**EVALUATION OF HALTON REGION
LANDFILL TECHNICAL STUDIES
Site F - Burlington**

HYDROGEOLOGIC REPORT

- **Part A - Definition of Hydrogeologic Suitability
for Landfilling**
- **Part B - Critique of Trow Technical Studies**
- **Part C - Interpretation of Site F Hydrogeology and
Suitability for Landfilling**

February 8, 1988

figure B.3.4
POTENTIOMETRIC DISTRIBUTION
Site 'F' - Hydrogeology - City of Burlington

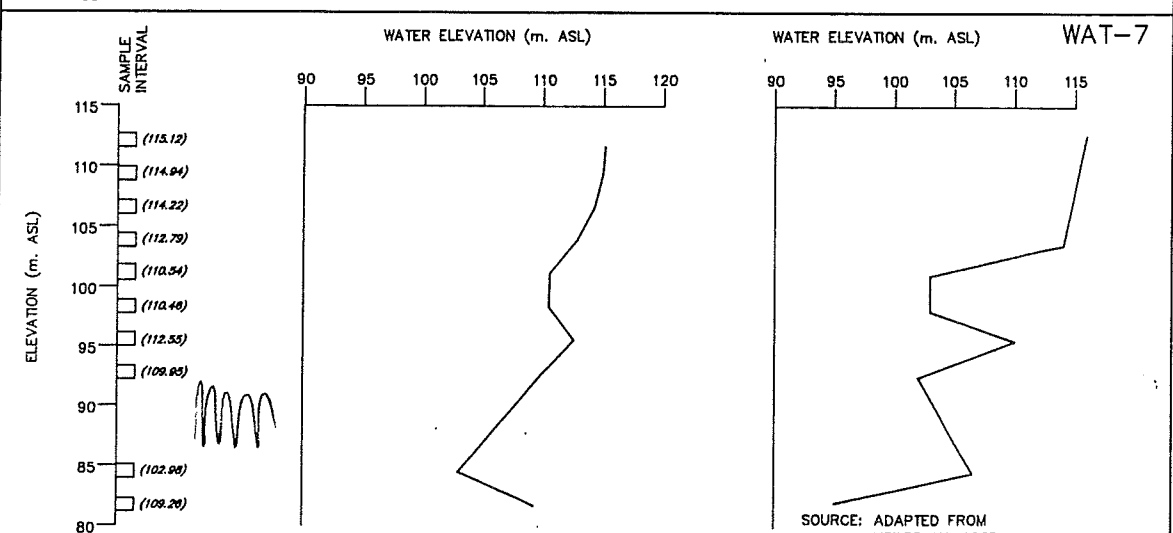
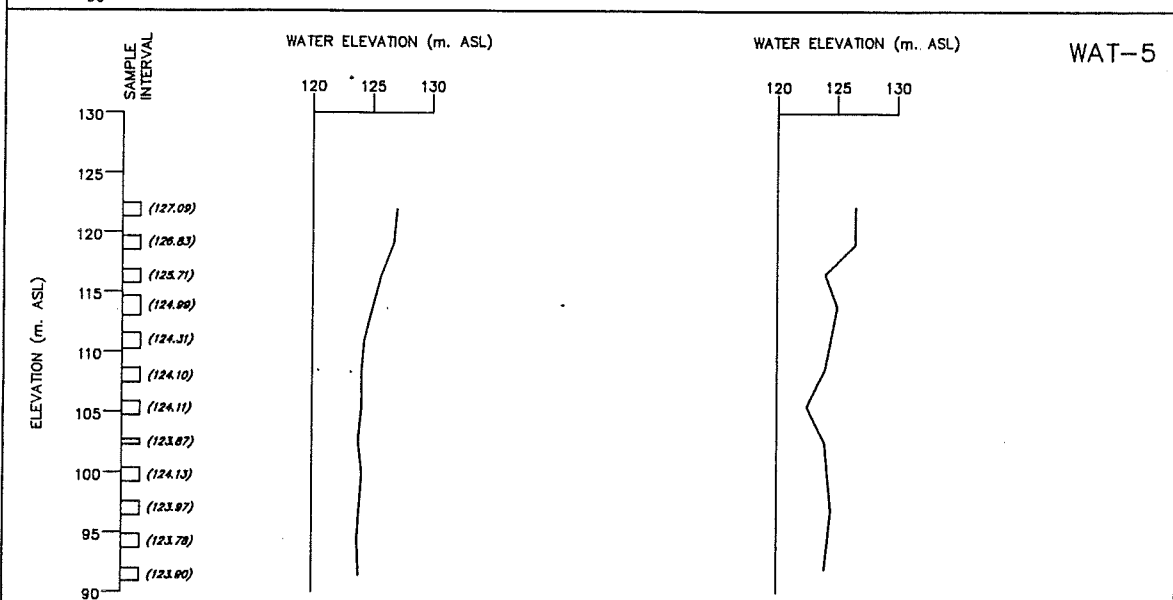
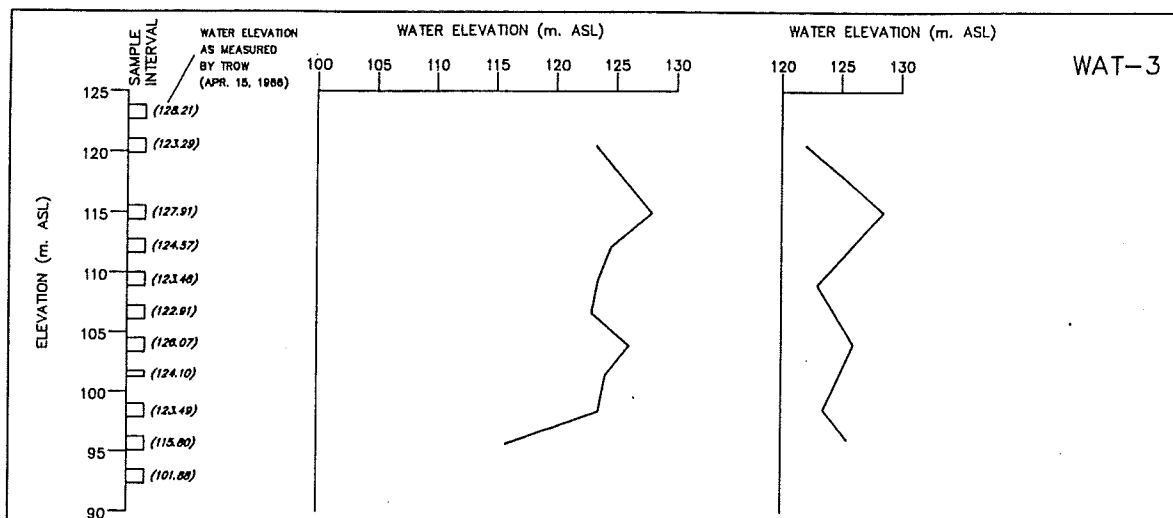
The available water level data for April 1986 (Trow, Appendix 5; Exhibit H-40A) are plotted and contoured on the base hydrogeological cross-section (Figure B.3.4, p. 32). This contoured distribution shows a trend to lateral groundwater flow in the upper portions of the bedrock

profile. At depth the groundwater flow is steeply downwards although this trend is less pronounced to the southeast i.e. downslope of the site.

(The existence of a 'highly fractured shale' (Unit 4) in which lateral flow would be expected to dominate is not apparent from this contoured pattern.) In addition, at HC4 steep downward flow is apparent only in the lower portions of the 'weakly fractured massive shale' (Unit 3) and not completely across this unit as is expected.

figure B.7.1
CROSS-SECTION OF PROPOSED LANDFILL
Site 'F' - Hydrogeology - City of Burlington

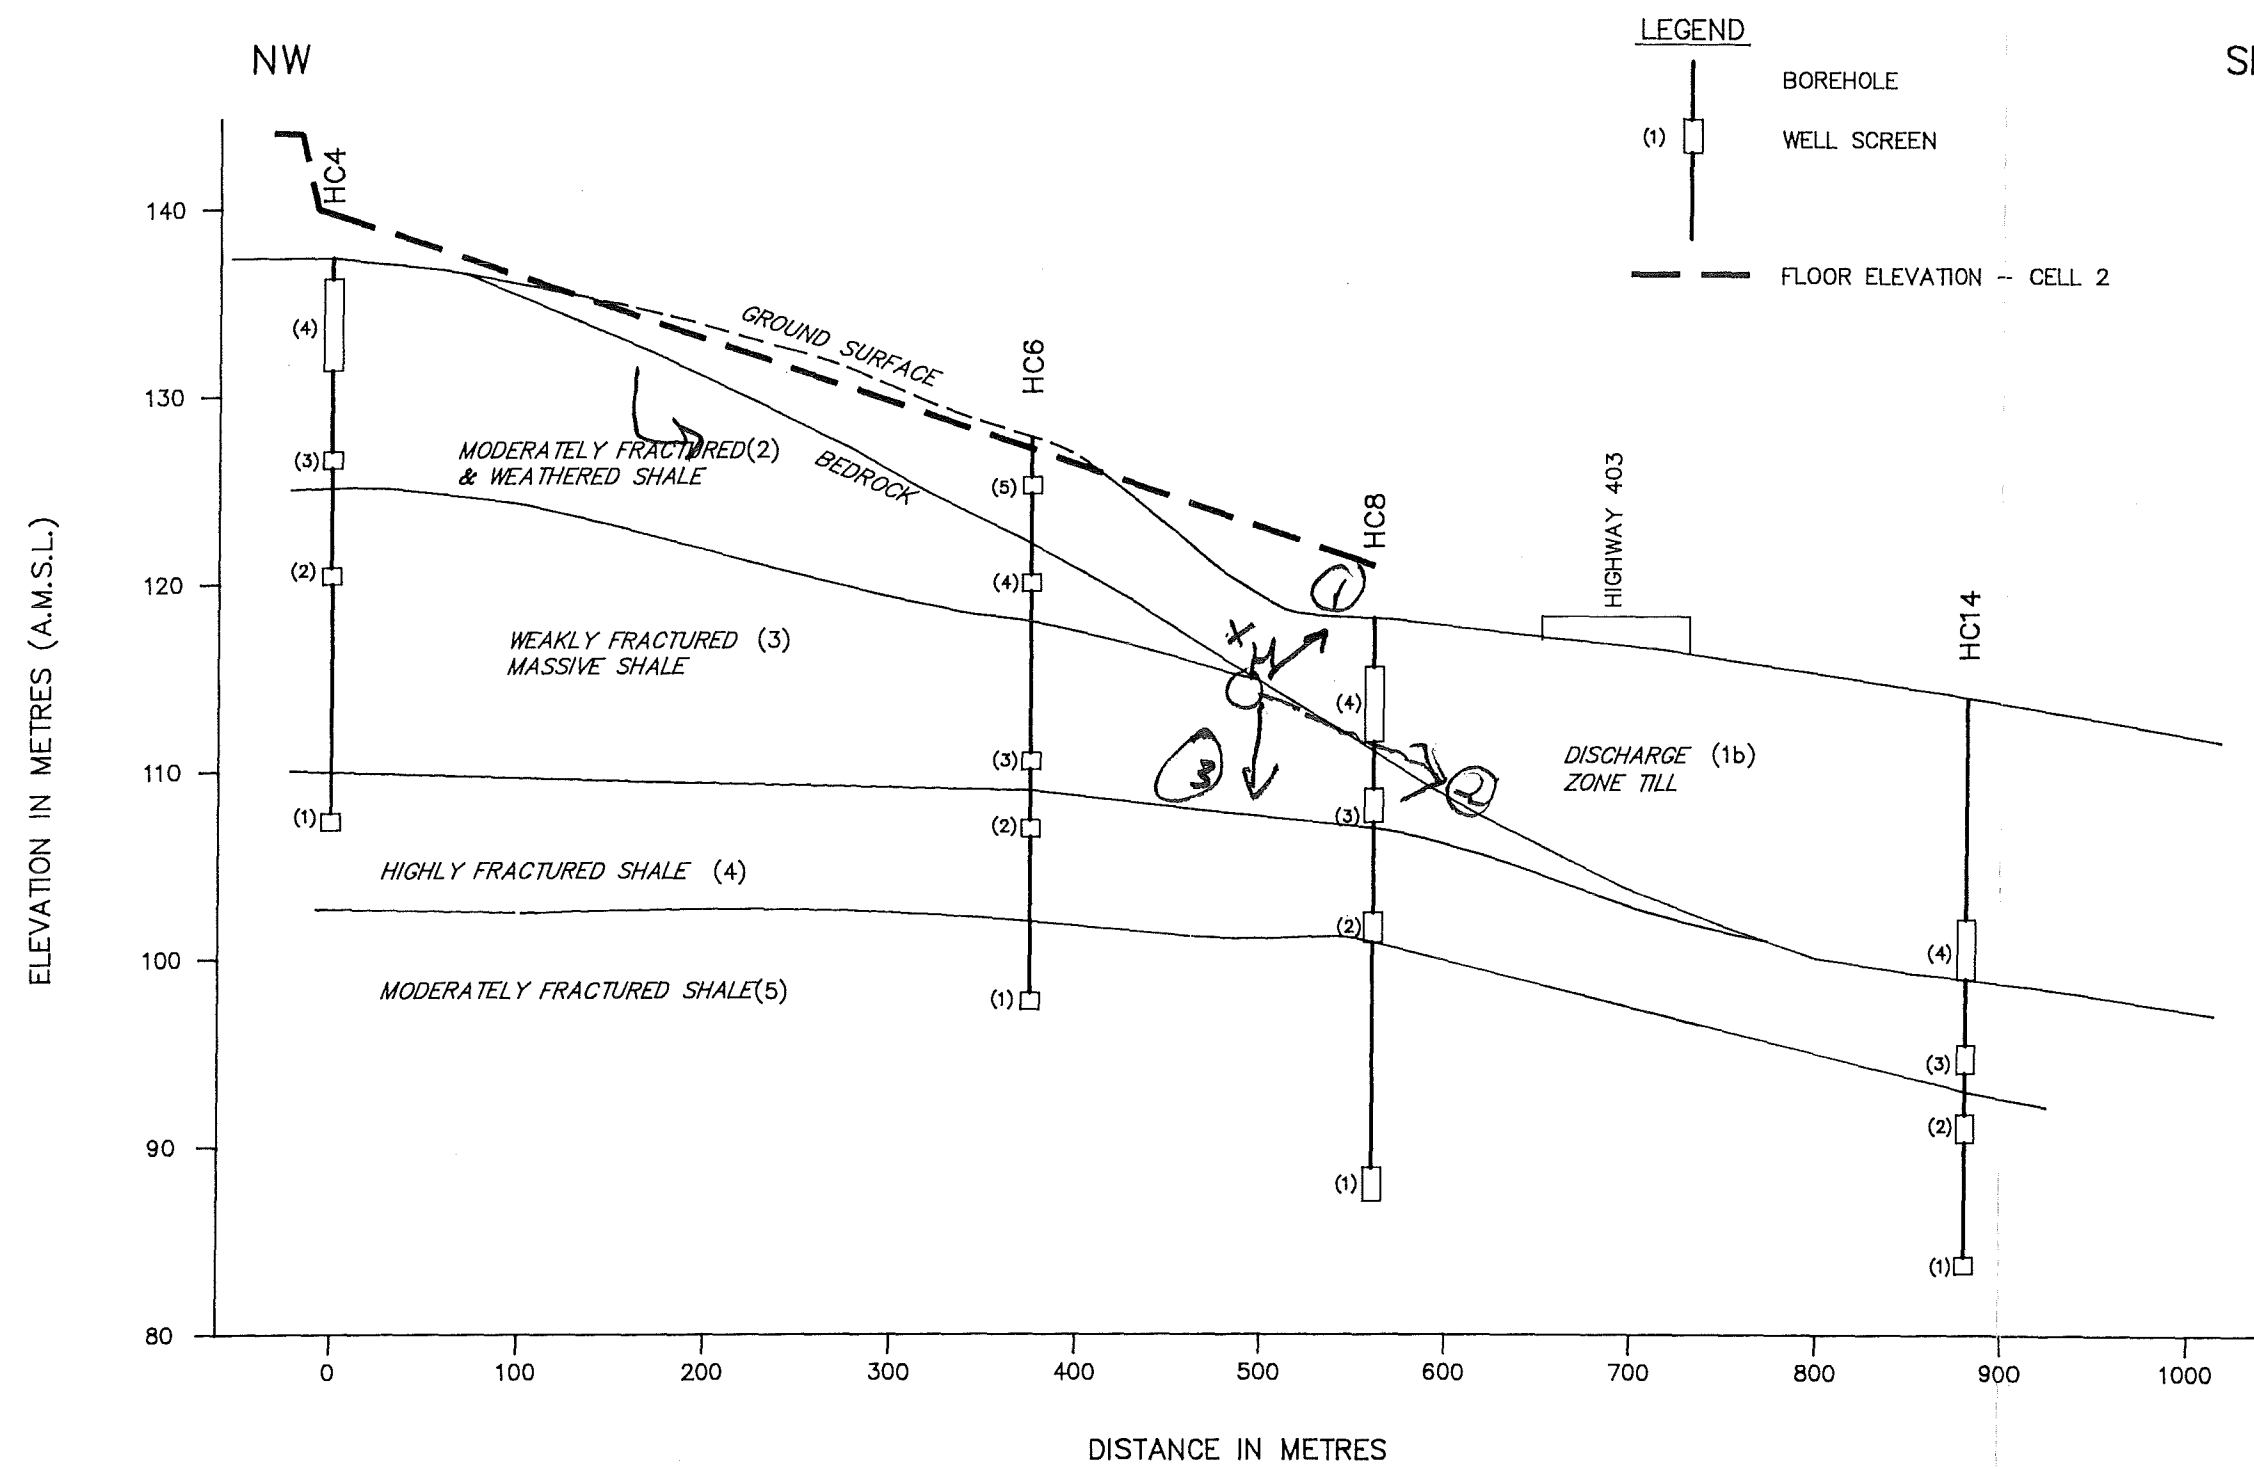
The base elevation of the proposed landfill excavation, as detailed by Trow (Drawing 5-r, Exhibit H-42B) was plotted by CRA on Trow's interpreted hydrostratigraphy (Figure B.7.1, p. 82). This figure demonstrates that a significant thickness of the 'moderately fractured and weathered shale' (Unit 2) remains below the excavation.

Trow did consider that this unit (Unit 2) could provide for the lateral migration of leachate below the landfill. However, on the basis of the computer modelling results (Figure 21, p. 125, Exhibit H-40), Trow concluded that this leachate would discharge to surface at the toe of the landfill immediately upgradient of HC8 where it could be collected. CRA does not agree with this conclusion for the following reasons:

figure C.3.2
DISTRIBUTION OF TRITIUM IN GROUNDWATER 1983, 1984.
Site 'F'-Hydrogeology - City of Burlington

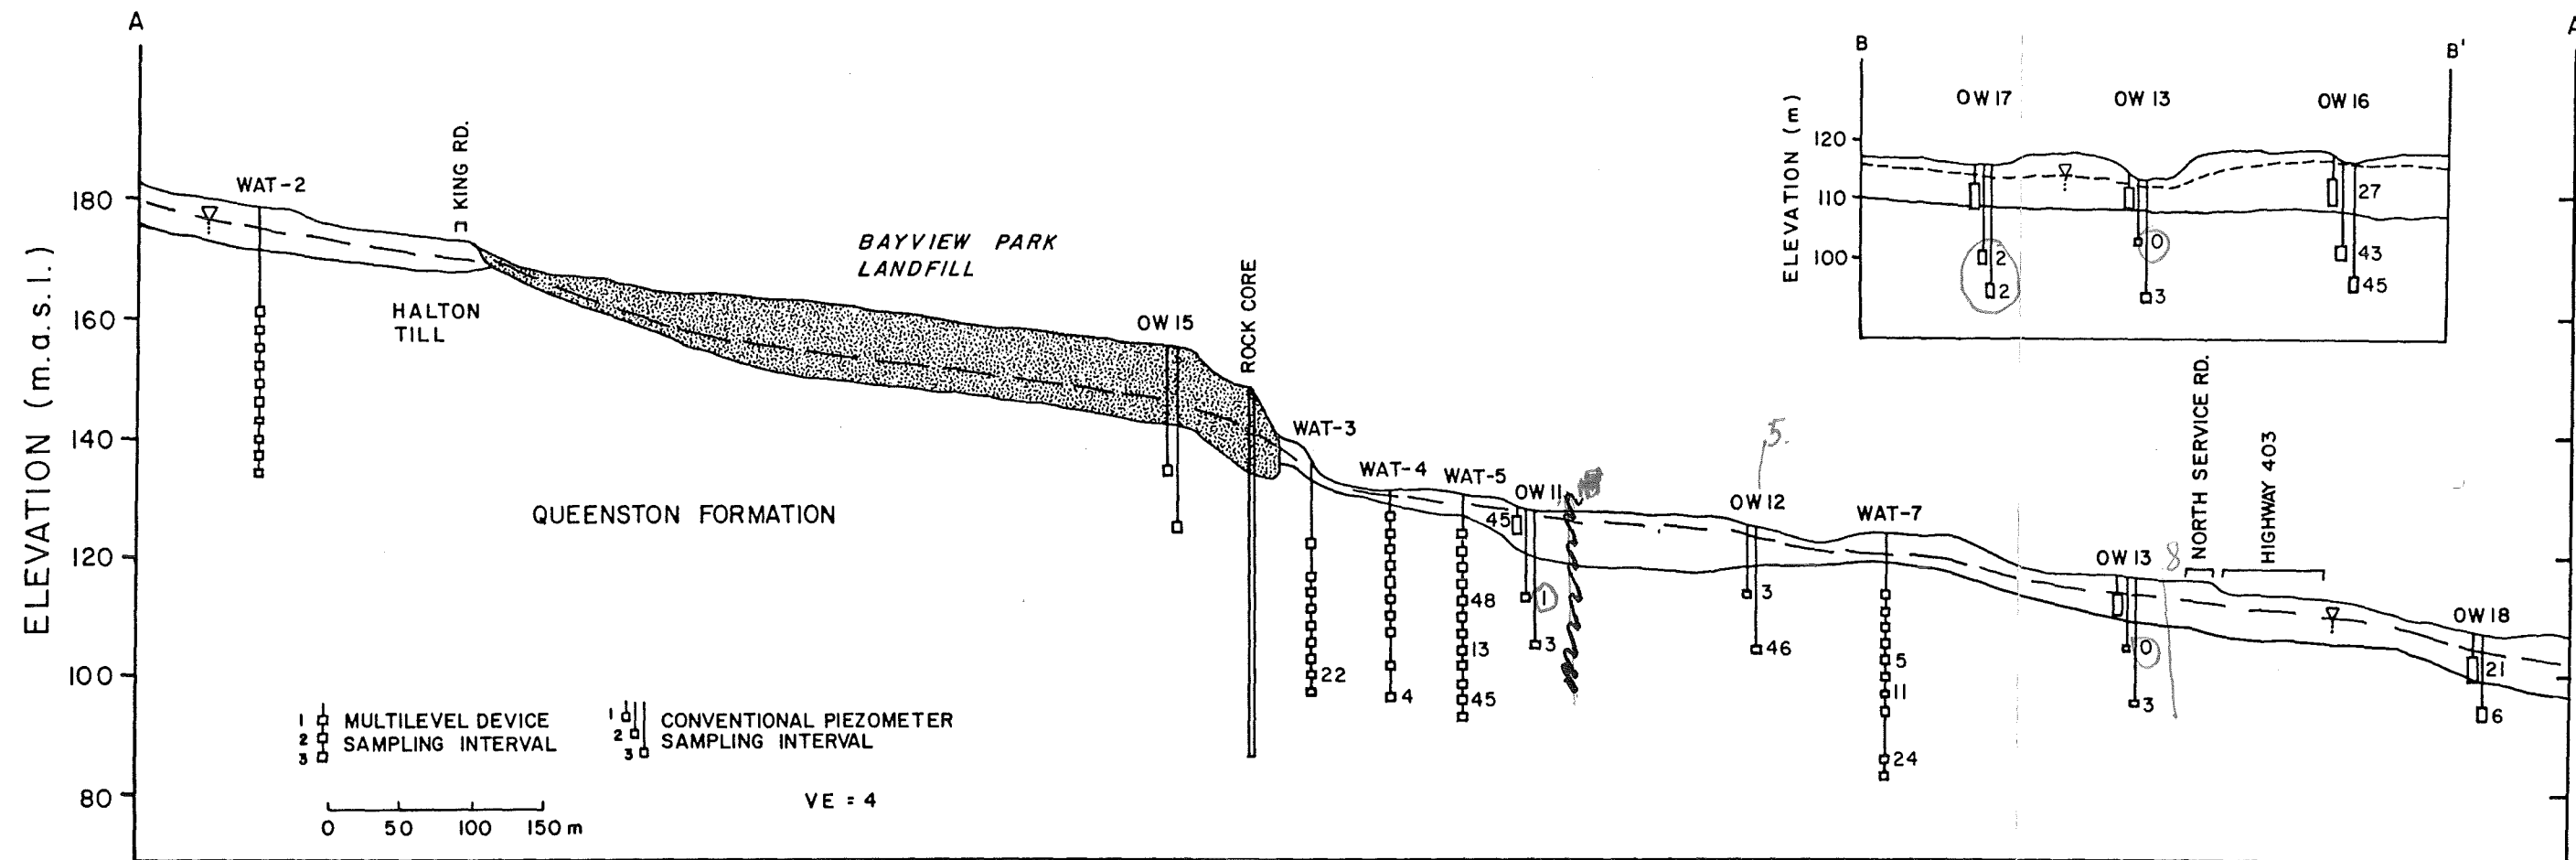
The distribution of tritium downgradient from Bayview Park as determined by Hewetson (1985, Exhibit E-214) is shown on Figure C.3.2, (p. 109). A trend to decreasing values at depth is obvious at two boreholes (OW11 and OW18). The reverse pattern is apparent at OW12 and WAT-7. Tritiated groundwater is encountered at depth at WAT-3 and WAT-5 while at a similar elevation in WAT-4, which lies between these two piezometers, non-tritiated waters are encountered.

The wide spread occurrence of tritiated groundwaters beneath the site indicates a hydraulically active flow regime, one in which groundwater, recharged by infiltrating precipitation since 1952, has migrated to a depth of at least 35 m. This indicates a significant degree of fracture connection between the surface and the deep rock.]
